STAFF REPORT

CITY OF LAKE OSWEGO

LU 14-0001
SV 14-0001

1235 Overlook Drive (Lakeridge High School)

Smooth and split faced CMU in charcoal, metal panels and substantial trim on gymnasium

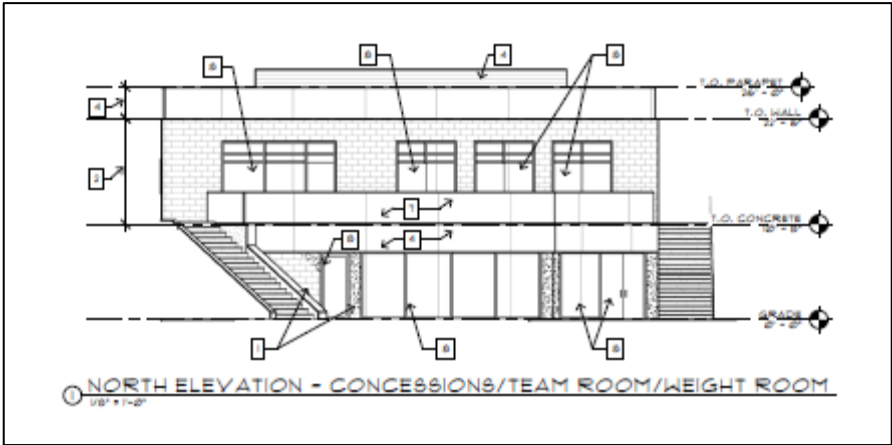
Both the stadium and the team/concessions building are designed with materials to match the existing school gymnasium, which is the closest portion of the school to the improvements, and essentially creates a background for them. The bottom of both structures is split-faced charcoal CMU, and the top portion is smooth-faced charcoal CMU. Pre-finished silver sheet metal panels are provided for the canopy and

press box – these match the aluminum panels on the gymnasium (see photos below). On the team/concessions building, the same silver sheet metal panel wraps the top, in proportion to the building, and provides screening for the mechanical units from the north and west (Exhibit E10). As shown on the roof plan for this building (above), the mechanical unit screening does not extend to the east and south elevations and the roof exhaust is partially exposed. As the primary approach to this building is from the southeast, with an elevation drop from the east parking lot to the stadium area, this screening should be extended to the east and south to fully screen the exhaust. As a condition of approval, this standard can be met.

As shown in the photos of the existing gymnasium, the windows have a substantial trim that provides a finished and less institutional look to the façade. The trim at the windows and doors on the team/concessions building are too narrow to provide a similar detail. As a condition of approval, the applicant will be required to provide trim at these doors and windows of at least 4” in width. As conditioned, this standard is met.
